Modification of Development Consent

Section 96 (1A) of the *Environmental Planning and Assessment Act 1979*

Development consent:	SSD 5300 granted by the Planning Assessment Commission on 7 March 2016
For the following:	Increasing the capacity of the existing construction and demolition waste and commercial and industrial waste recovery facility
Applicant:	Bicorp Pty Ltd
Consent Authority:	Minister for Planning
The Land:	50 Wyllie Road, Kembla Grange (Lot 10 DP 878167)
Modification:	SSD 5300 MOD 1: the modification includes: • relocation of the new second weighbridge to the west by 4 m and to the south by 9 m to accommodate the larger weighbridge office and to align with the existing weighbridge; • installation of a larger demountable weighbridge office with an area of 36 m²; • minor widening of the access carriageway to the inbound and outbound weighbridge resulting in an increased area of 321 m²; • redirection of rainwater from weighbridge office to an on-site 500 L rainwater harvesting tank; and • connection of overflow rainwater to the existing stormwater management system on the site.

SITE PLAN
NTS

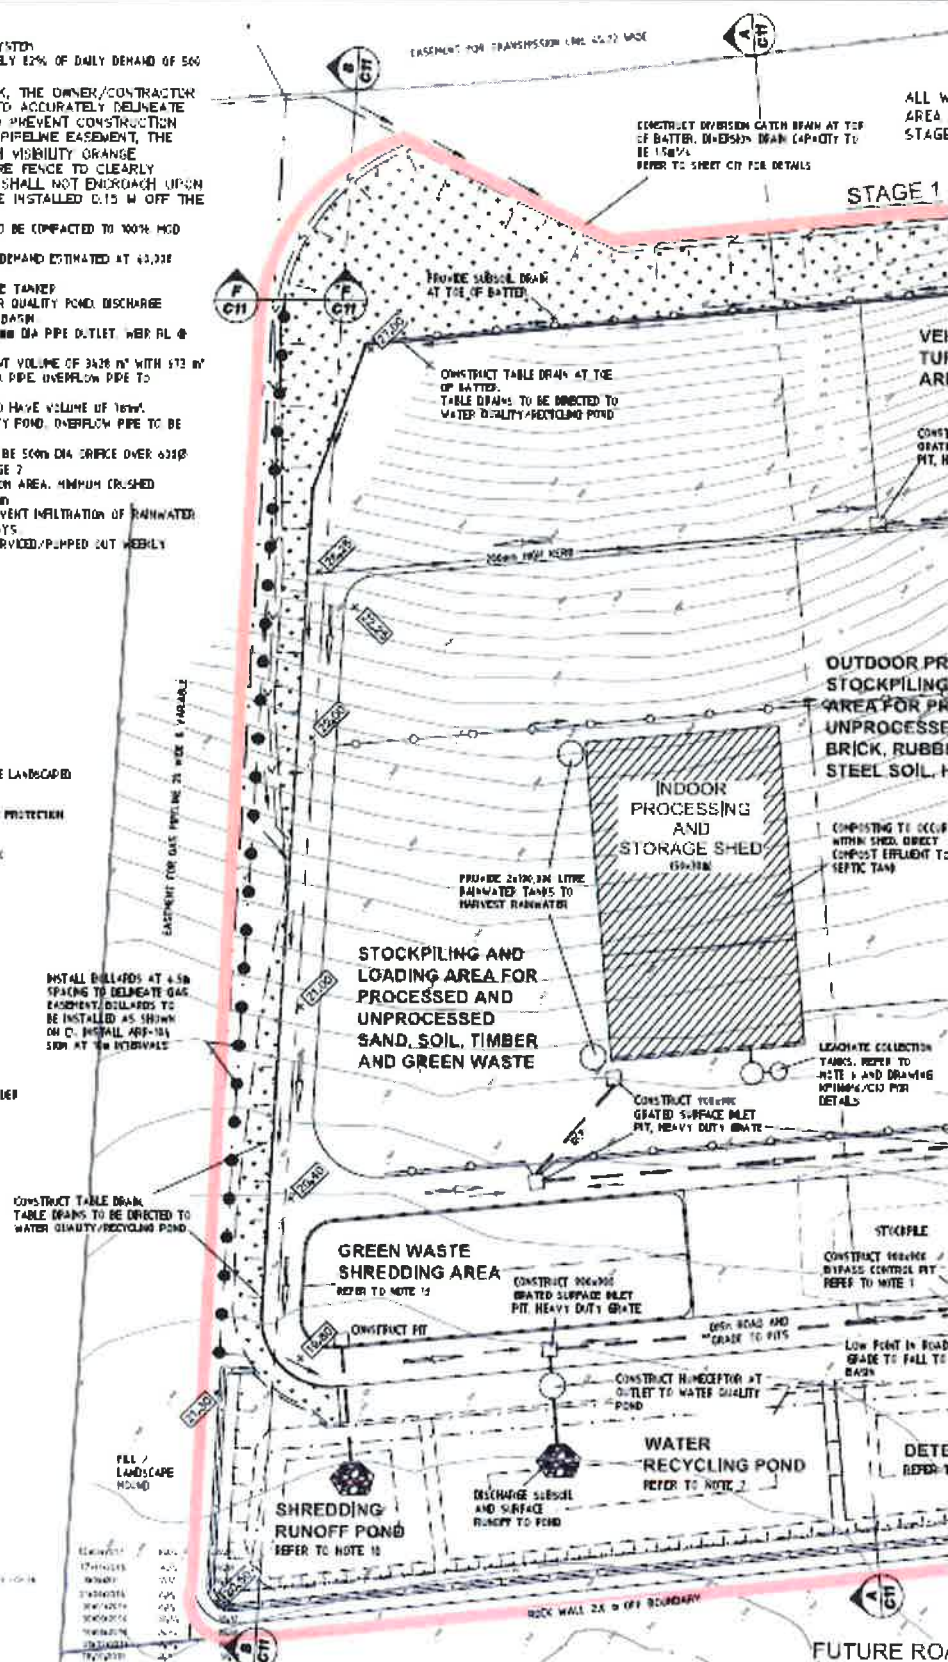
- a) EIS;
 - b) Response to Submissions;
 - c) site layout plans and drawings (see Appendix A); and
 - d) Management and Mitigation Measures (see Appendix B).
 - e) **The S96(1A) Modification Application to SSD 3055, prepared by Jackson Environment and Planning, dated 2017;**
- (b) Appendix A is amended by the deletion of all drawings, and the insertion of the following drawings:
